Charlotte Historic District Commission Staff Review HDC 2013-119

Application for a Certificate of Appropriateness Date: September 11, 2013

PROPERTY ADDRESS: 1909 Wilmore Drive

SUMMARY OF REQUEST: Addition

ELEVATIONS (W & S)

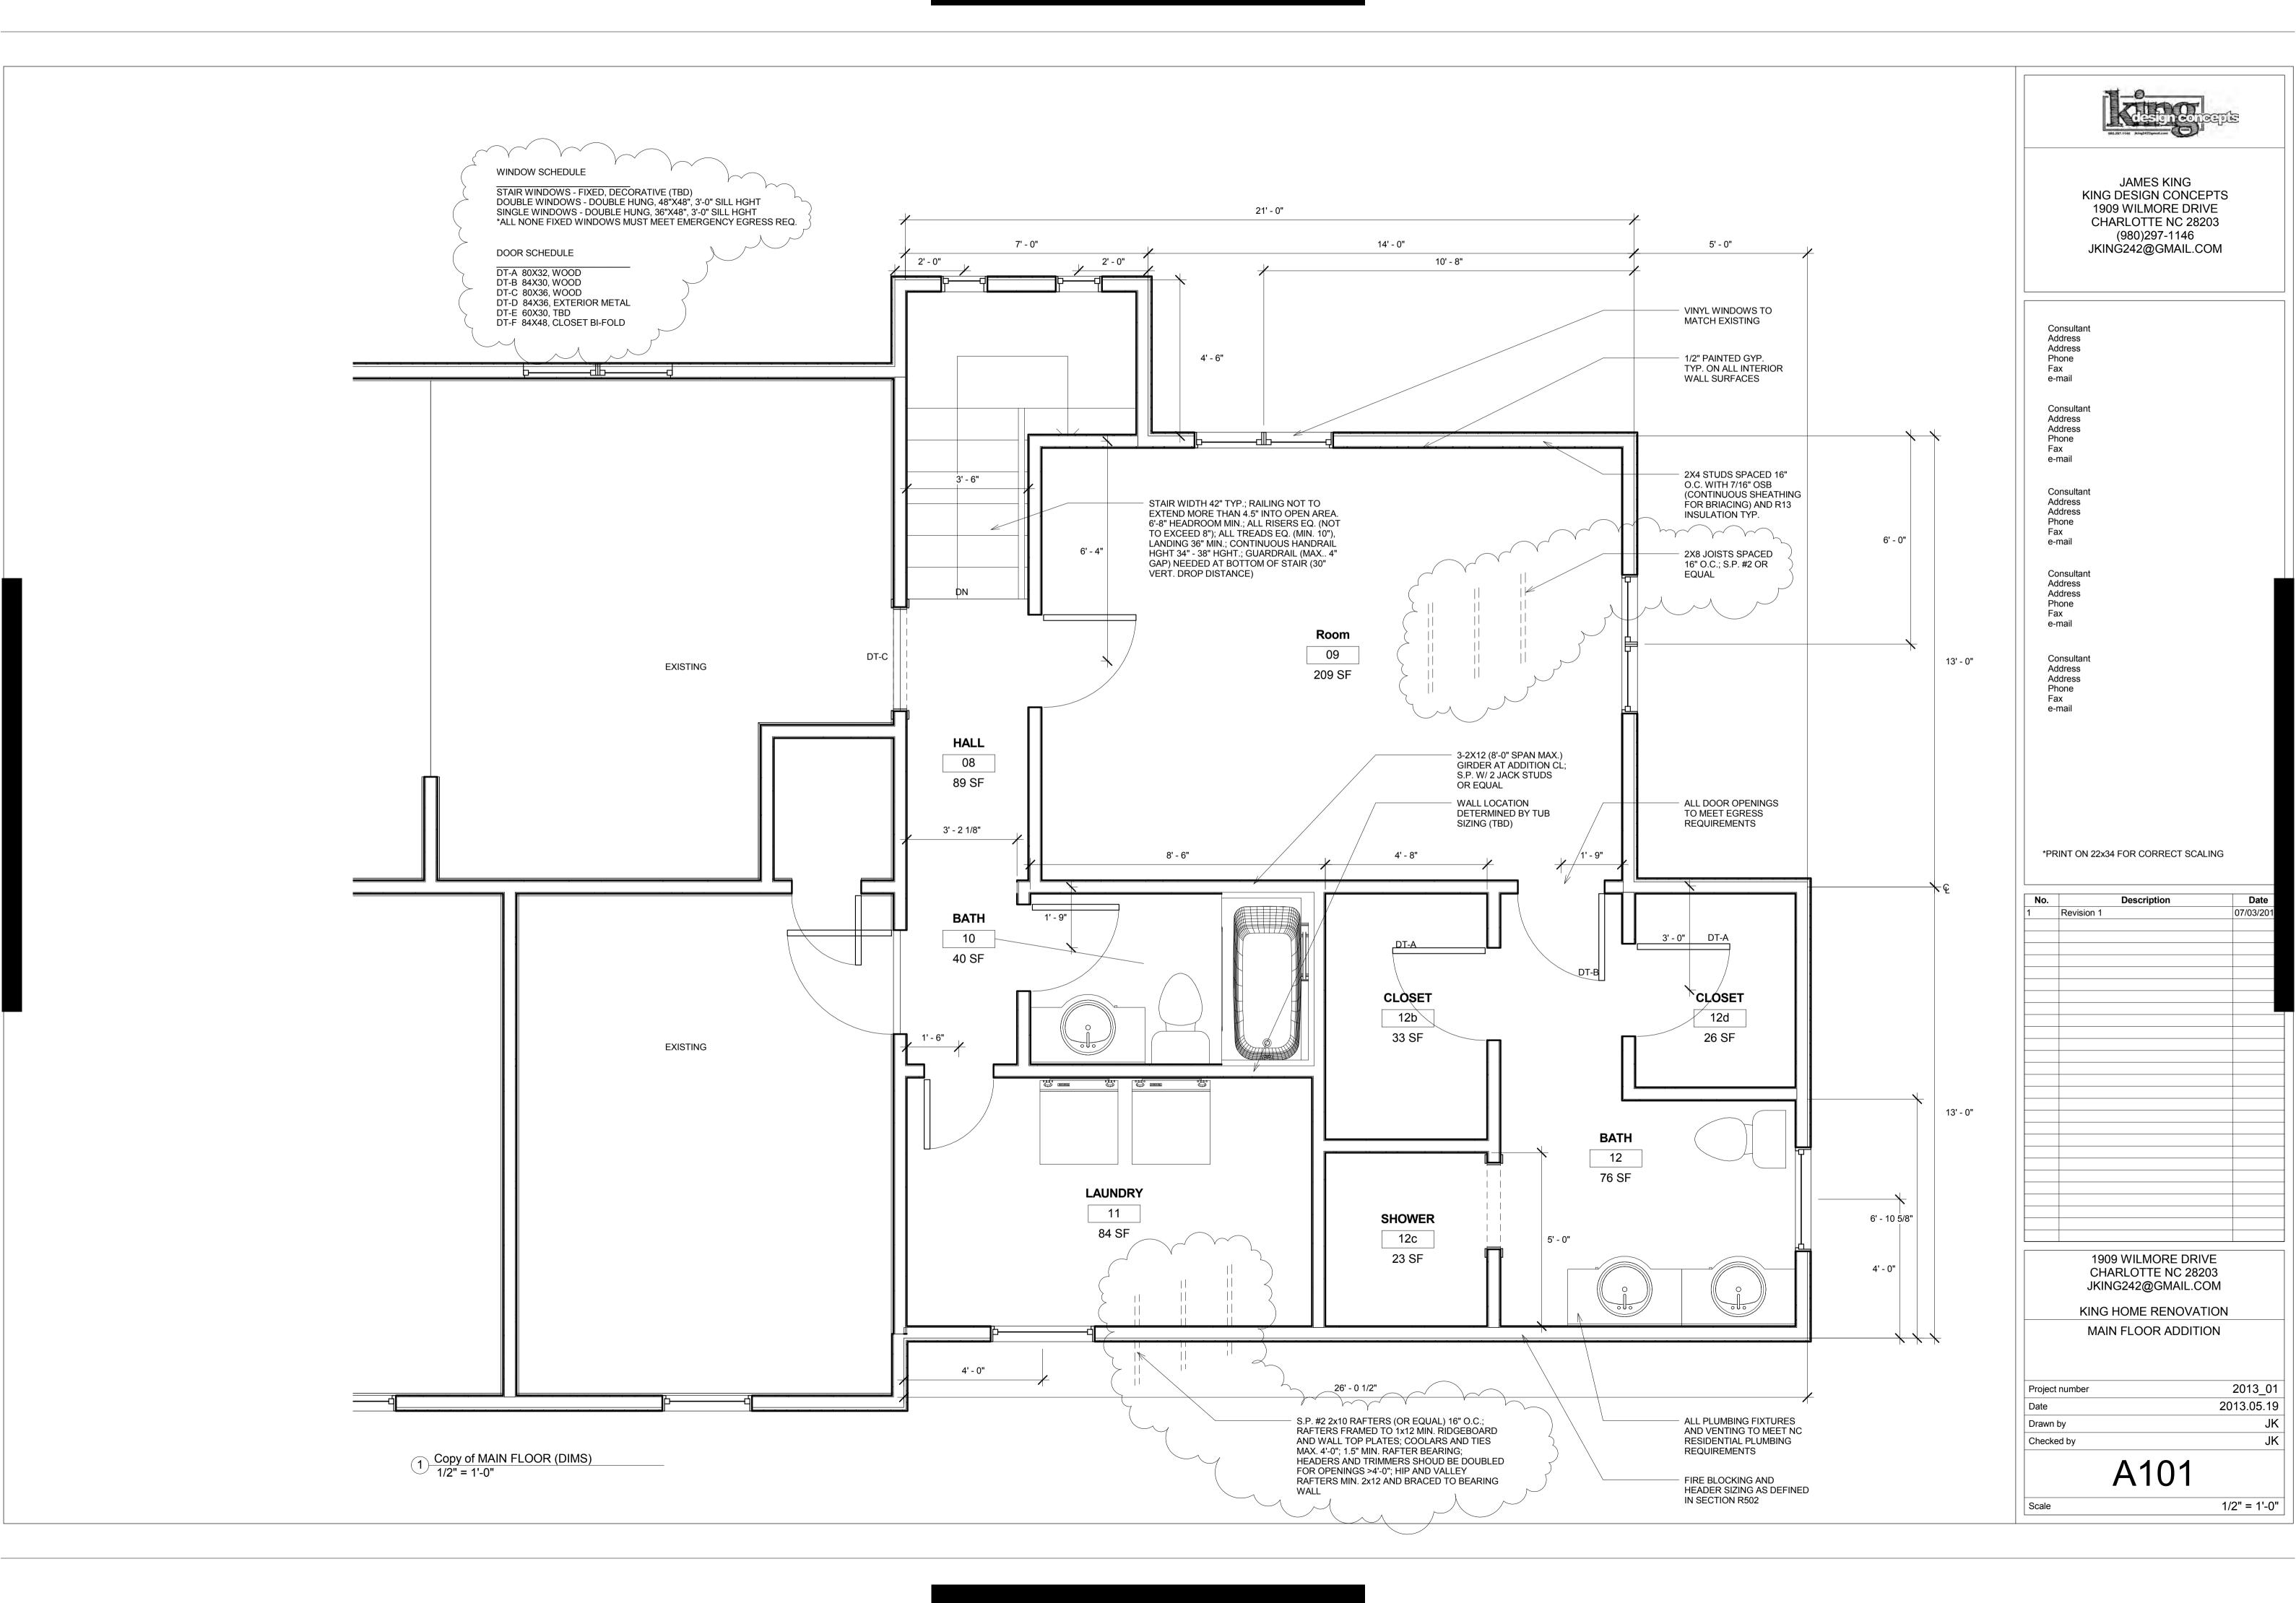
The proposal is an addition at the rear of the home resulting in a second story that will tie into the existing roofline due to the slope of the land. The side elevation shows the addition lower than the existing roofline. The front (west) elevation shows a portion of the addition that will be visible from Wilmore Drive. The plan indicates painted brick to match the color of the siding. Existing mature trees would not be disturbed.

The application was deferred in August to address the siding material and windows along the new staircase. The plans have been revised to add German lap wood siding as a material option. The window on the stairtower matches the window on the new main floor.

Staff believes the proposal meets all of the Guidelines for Additions, provided wood siding is used as noted.
